Model: R6400v2

Model: R6700v3

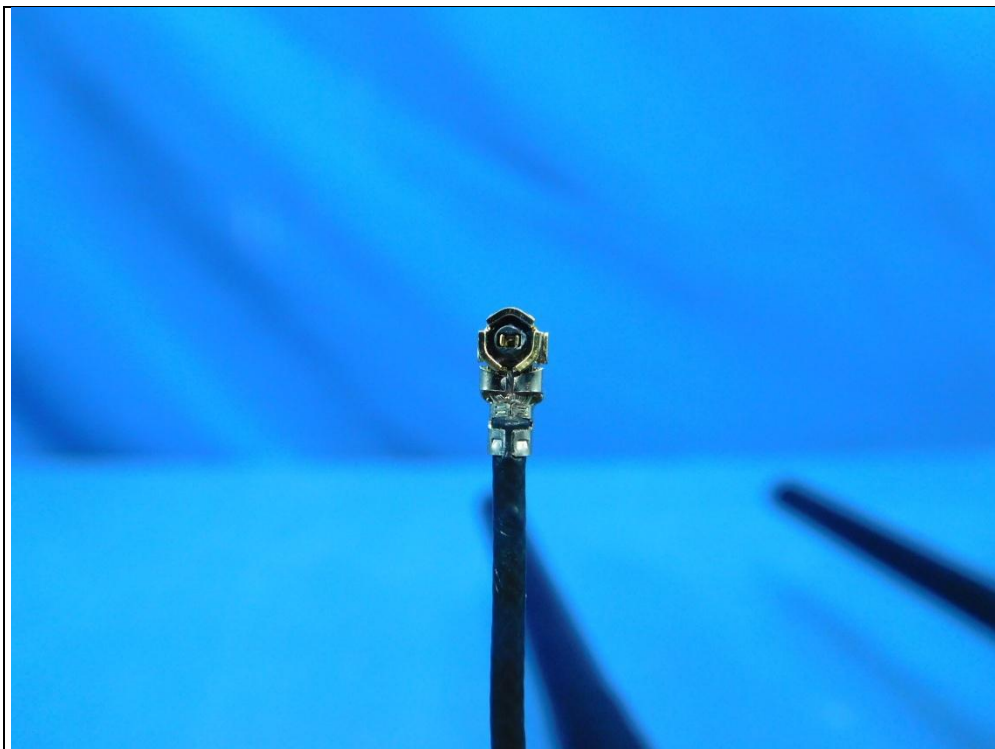
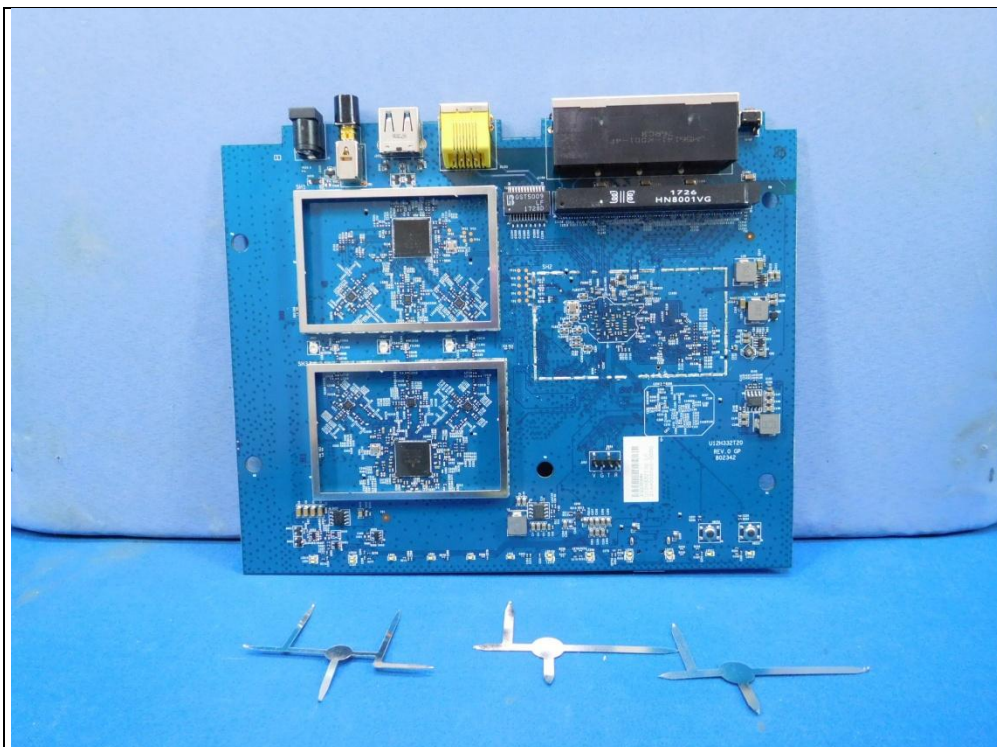
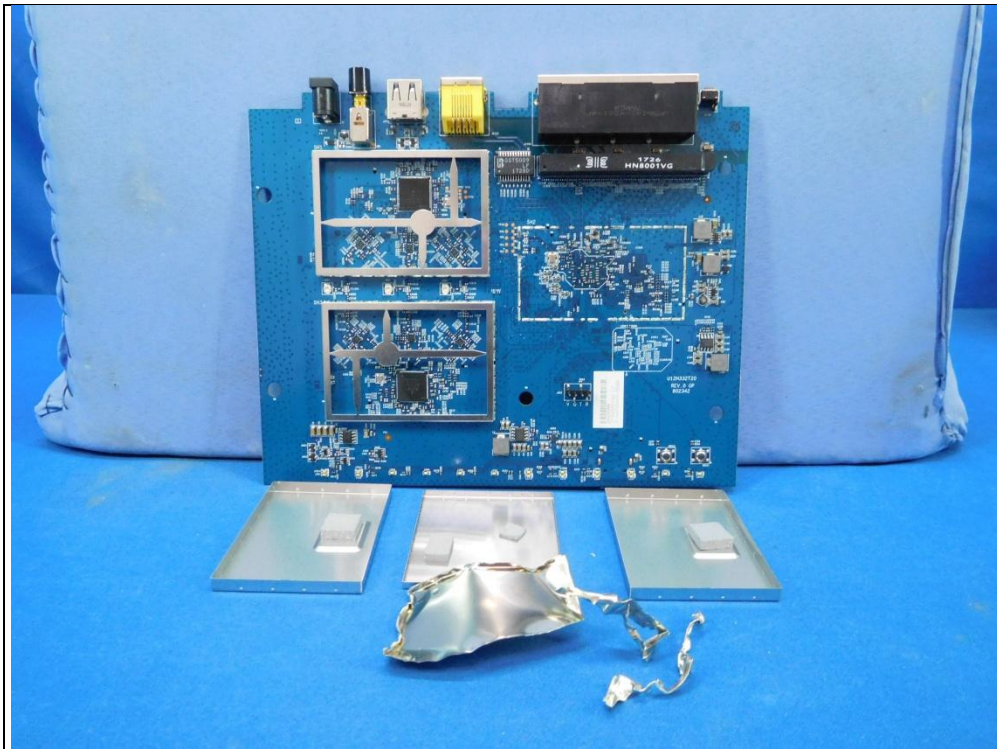
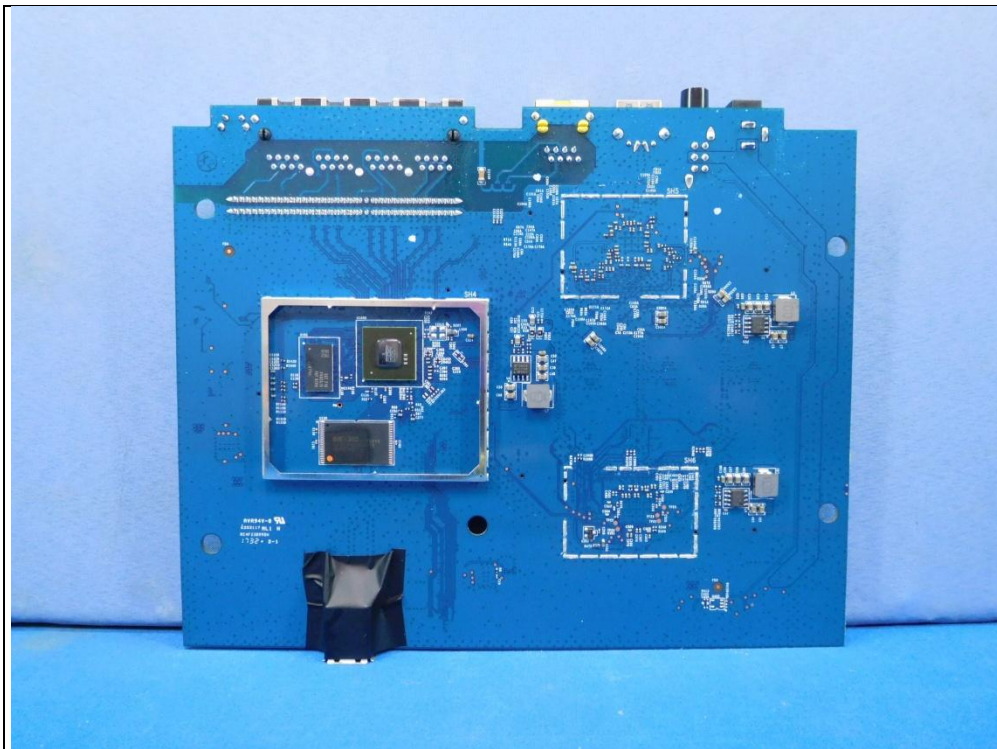
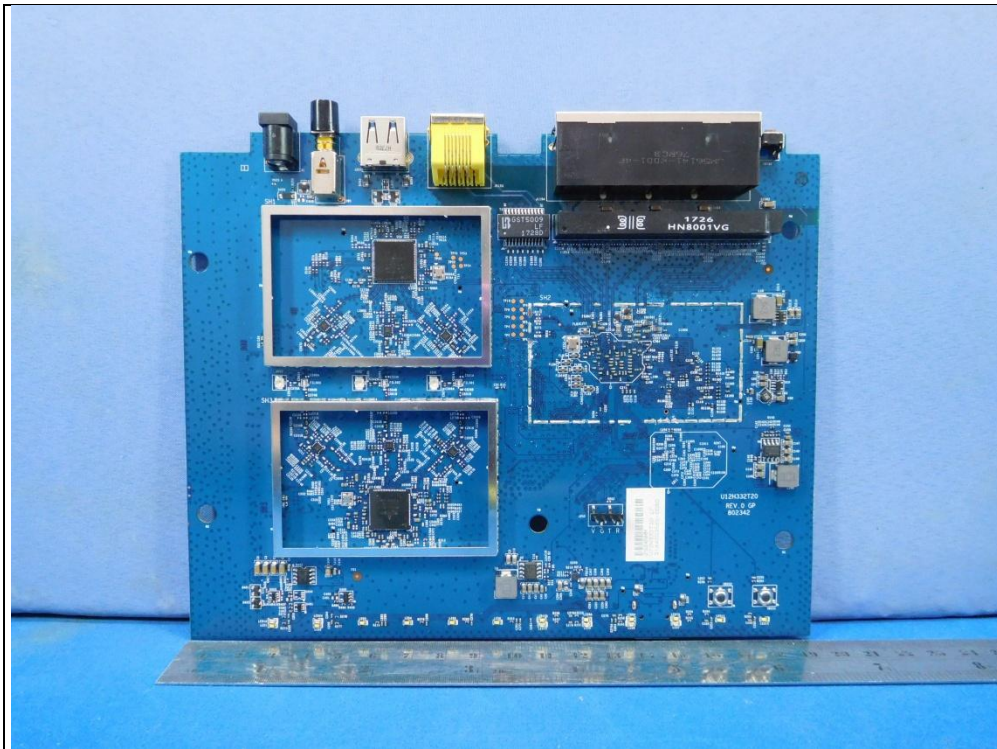
Reduce the heatspreader's size
Original: 226x127mm

Newly: 196x90 mm

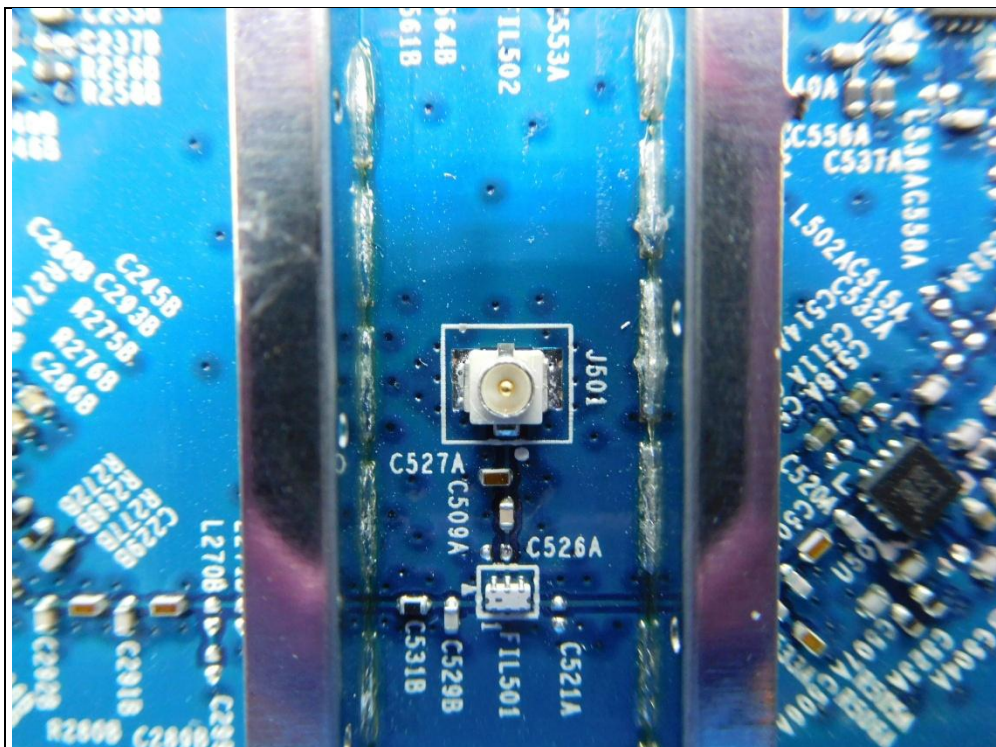
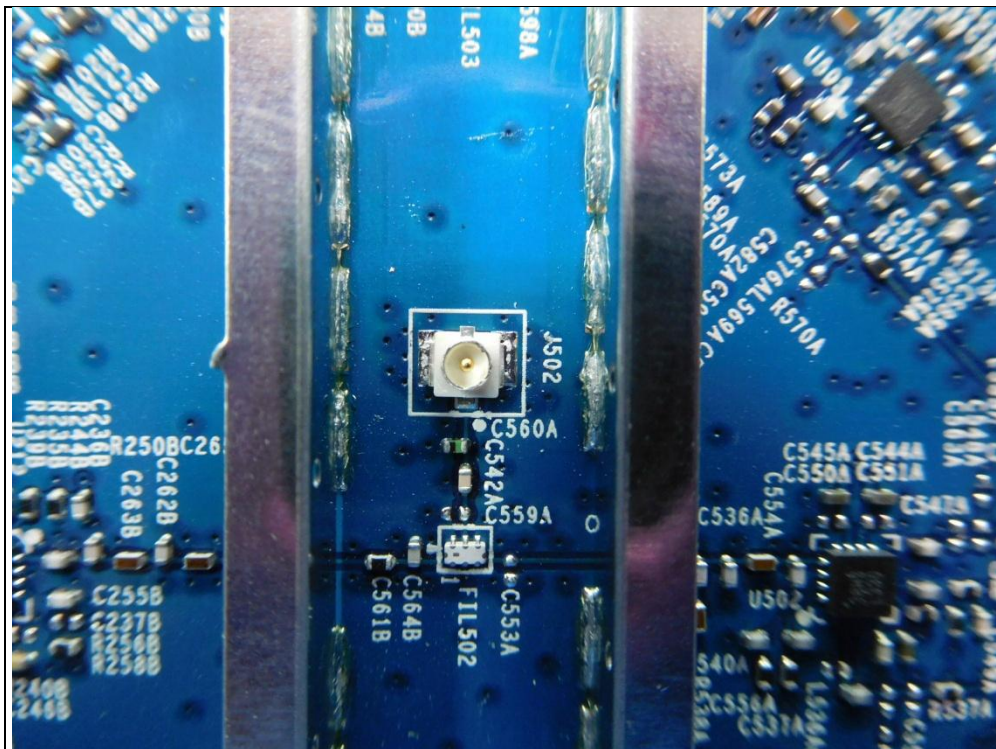
(The difference is removed USB 2.0 to compared with R6400v2, please see below photos on page 17~20)
